Project Name: Culver's
 Description: Preliminary site plan approval
 Date on Agenda this packet pertains to: May 2, 2024

RE: Culver's- Preliminary Site Plan Review – 2nd Review

RE: Culver's
Preliminary Site Plan – Review #2

PHASE: P. SPA
JOB NO.: 230601
C301

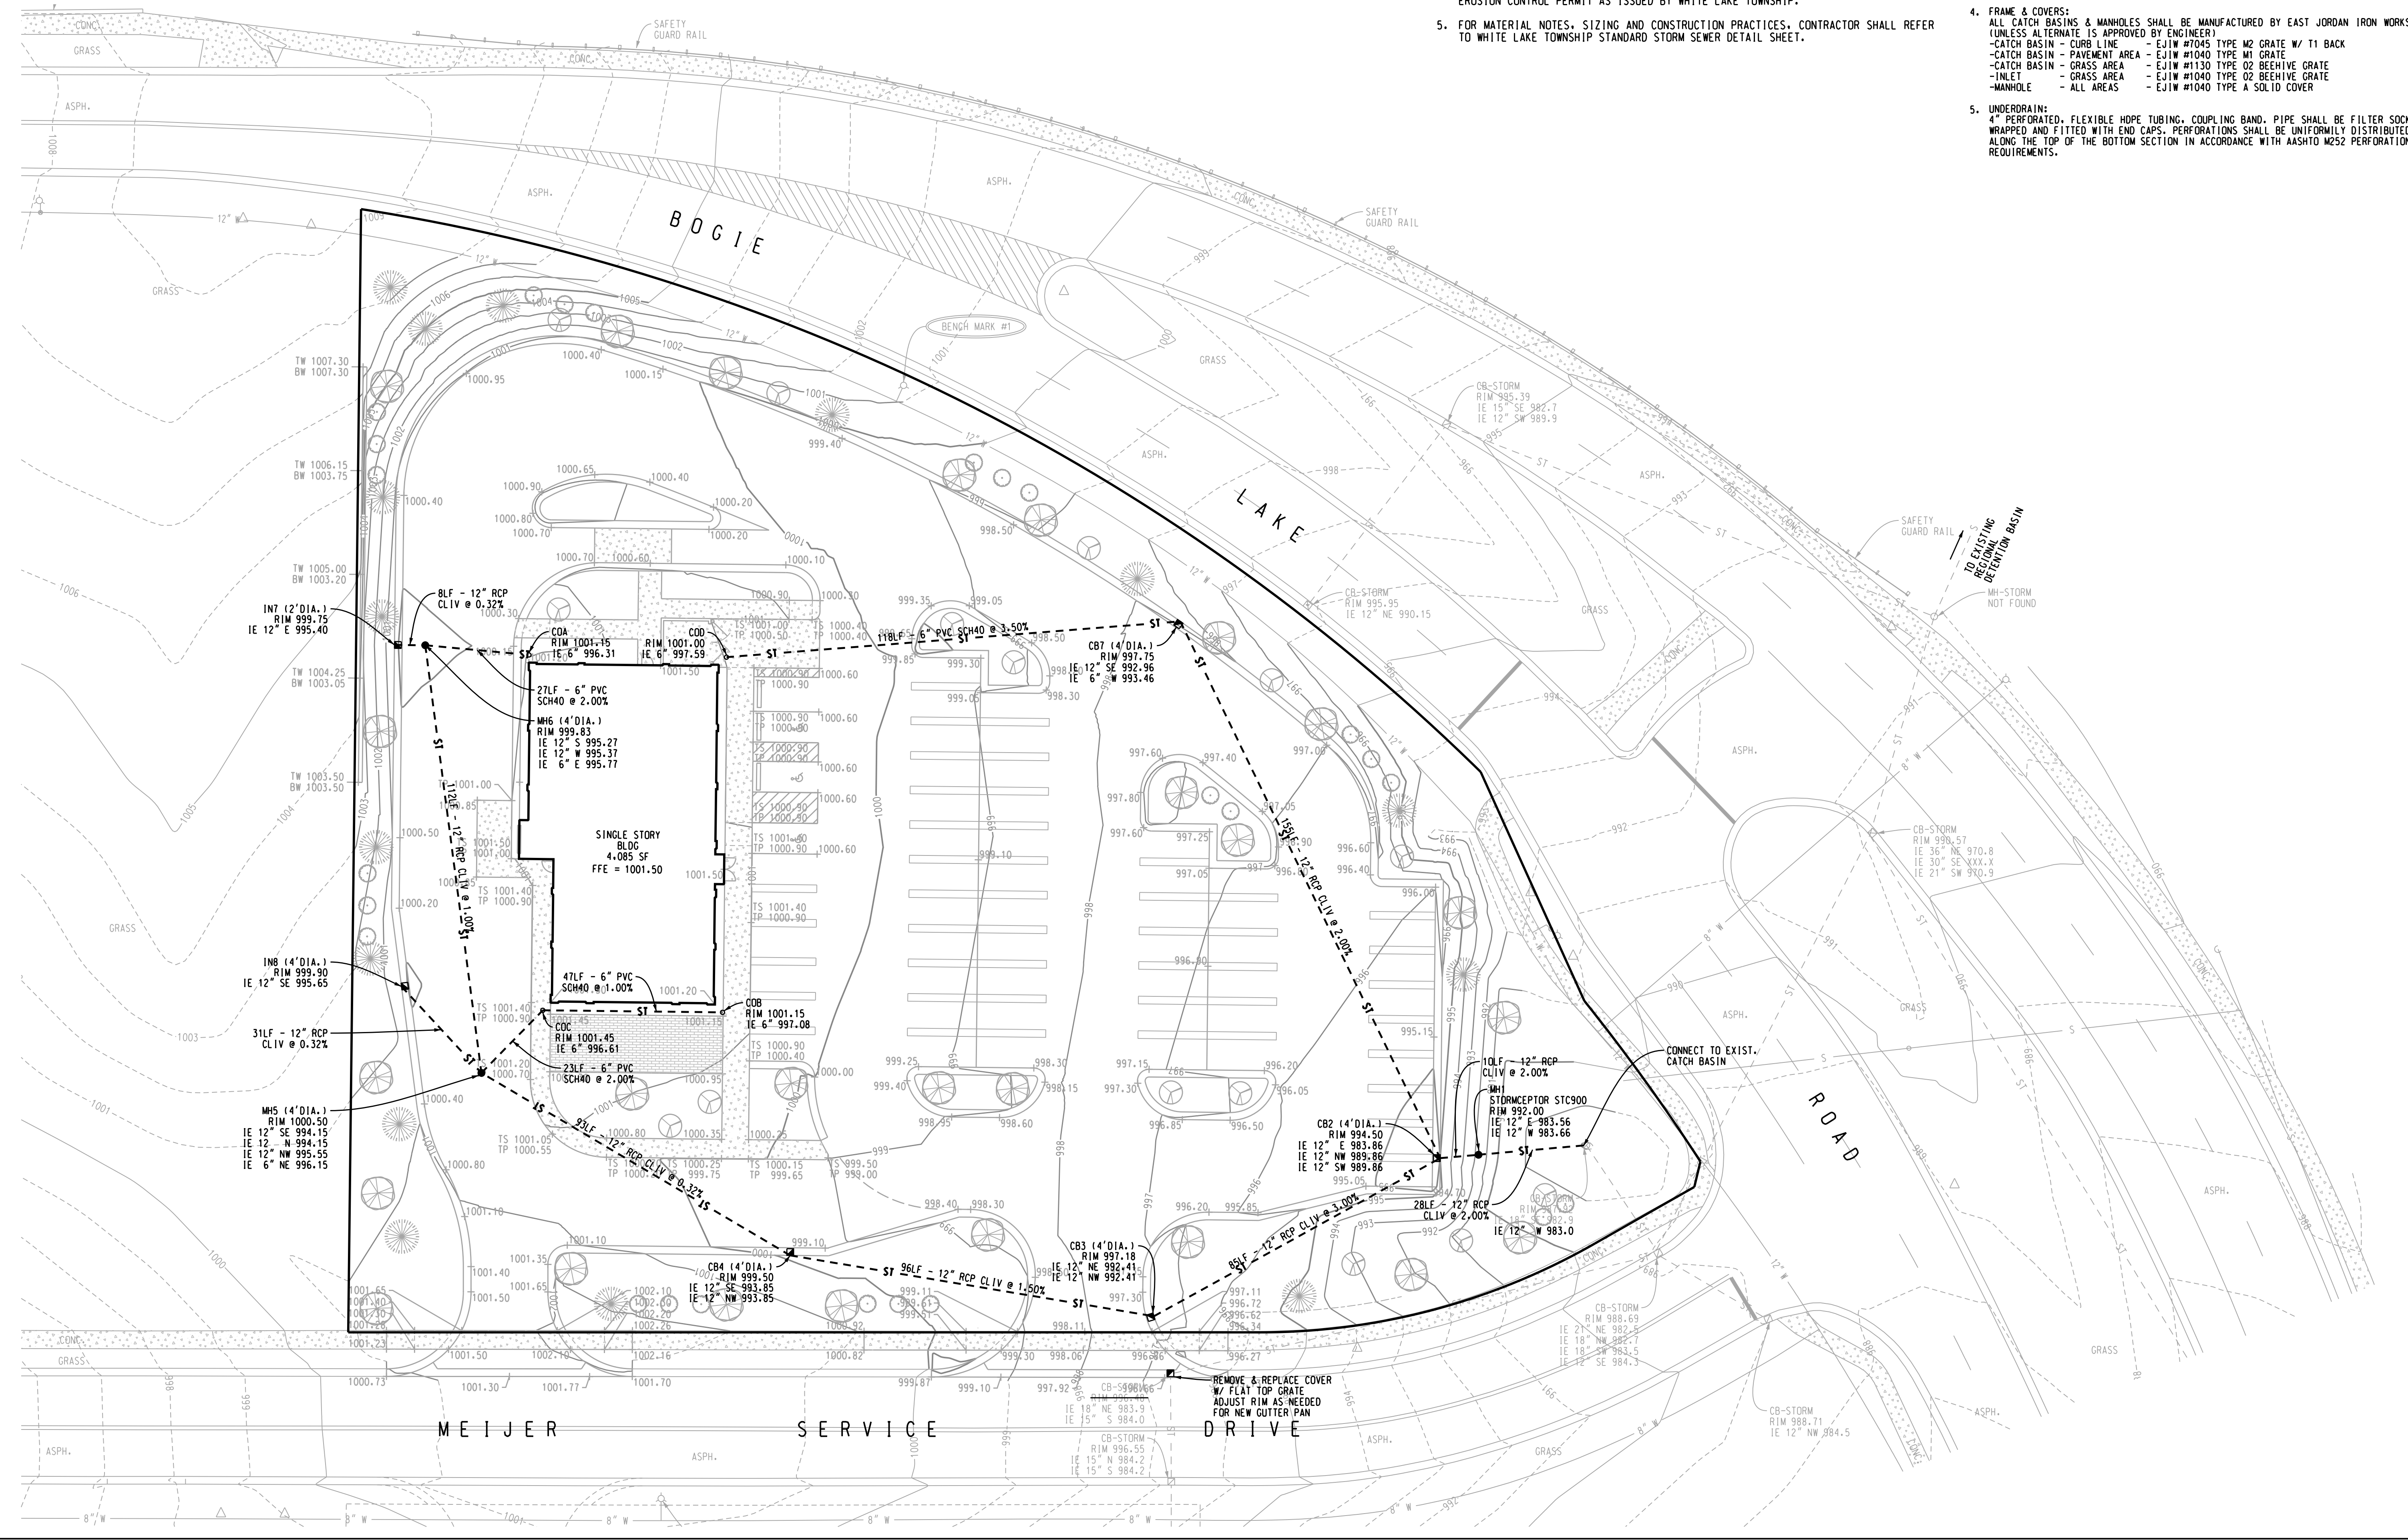
- p) *Sheet C301- Based on the existing storm sewer invert (per Meijer storm sewer as built plan) for EX1 of 984.85, storm drainage would back up in proposed Stormceptor (MH1) and remainder of proposed pipe (CB2 -EX1) and into CB2. Please review and revise, including storm sewer calculations, as necessary. In addition, please reference comment e) above. Comment addressed, grades were confirmed by surveyor and positive drainage is anticipated.*

- q) *Sheet C301-The proposed storm sewer is too close to the proposed retaining wall. Please shift sewer further to the east. Comment addressed. Storm sewer layout has been revised such that storm sewer is now shifted away from proposed retaining wall.*

PHASE: P. SPA
 JOB NO.: 230601
 C400

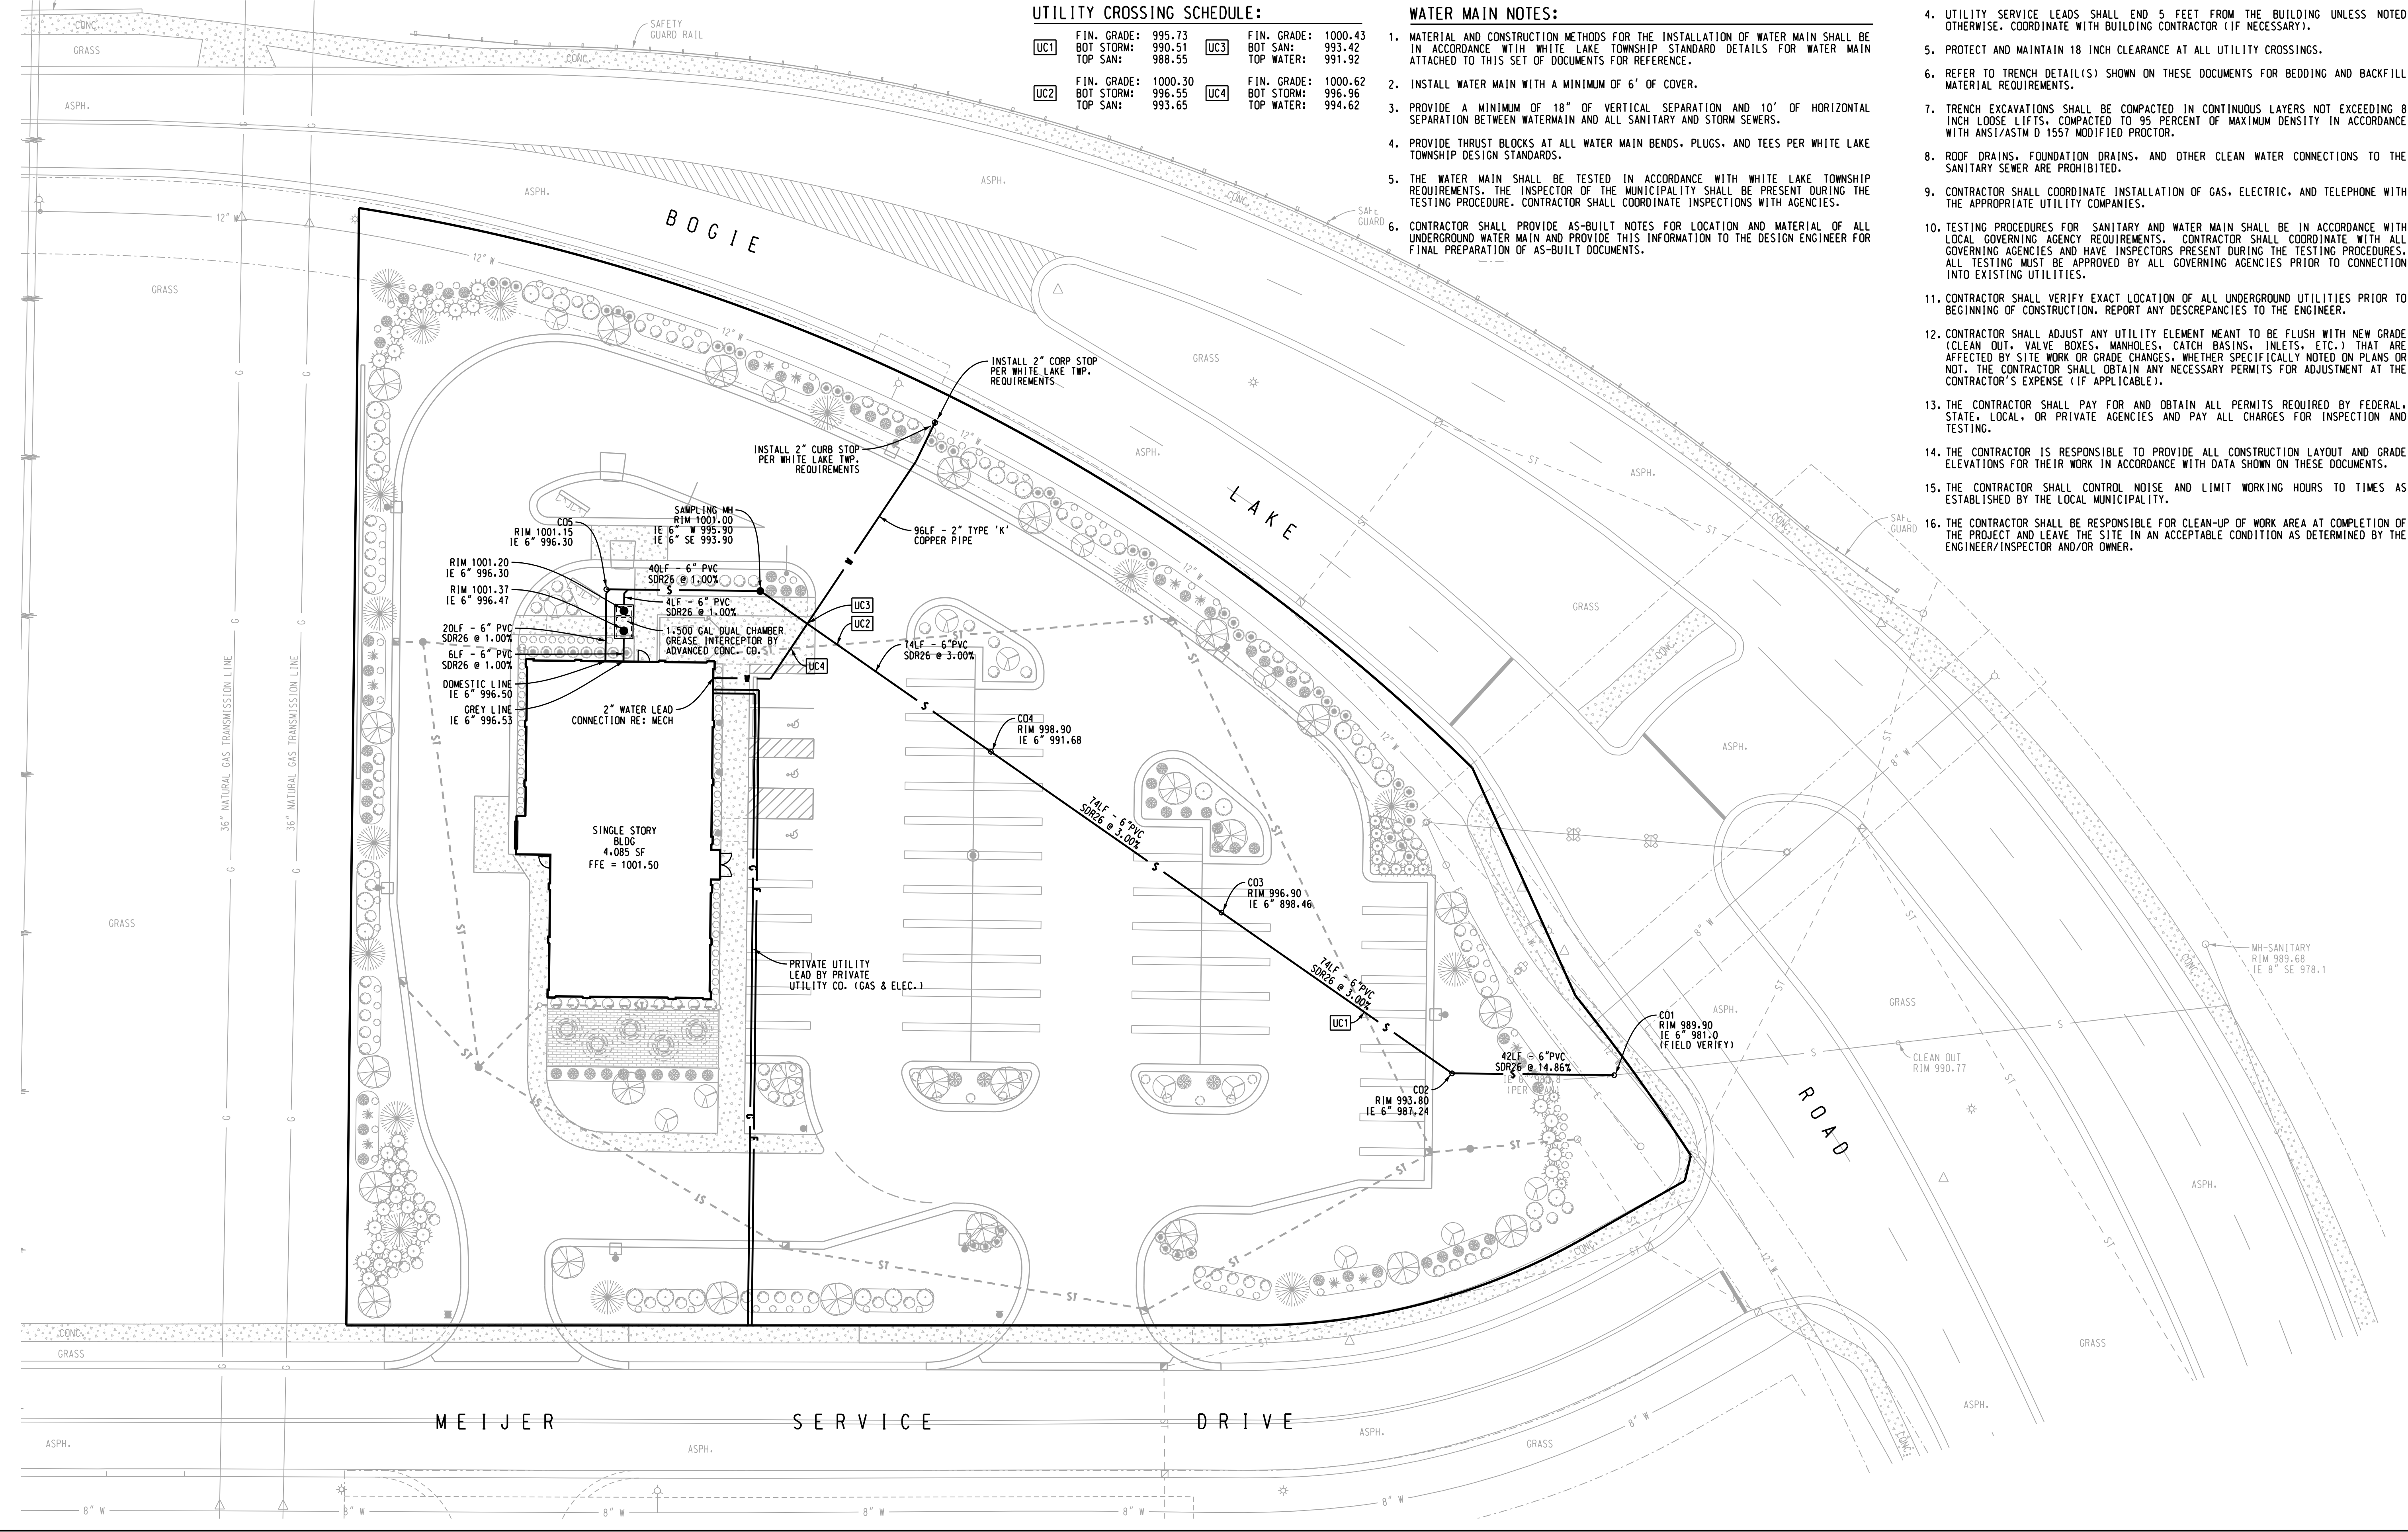
- r) *Sheet C400-The proposed sanitary sewer pipe diameter shall be required to be 8" diameter (8" required if pipe length > 150'). Comment addressed. 6" lead will suffice based on conversation with our office.*

- s) *Sheet C400- The proposed sanitary sewer lead will be required to be lowered at water service crossing UC3 to achieve the minimum required 18" vertical pipe separation. Comment addressed. The water lead has been lowered and placed a minimum of 18" vertical separation under the sanitary lead.*
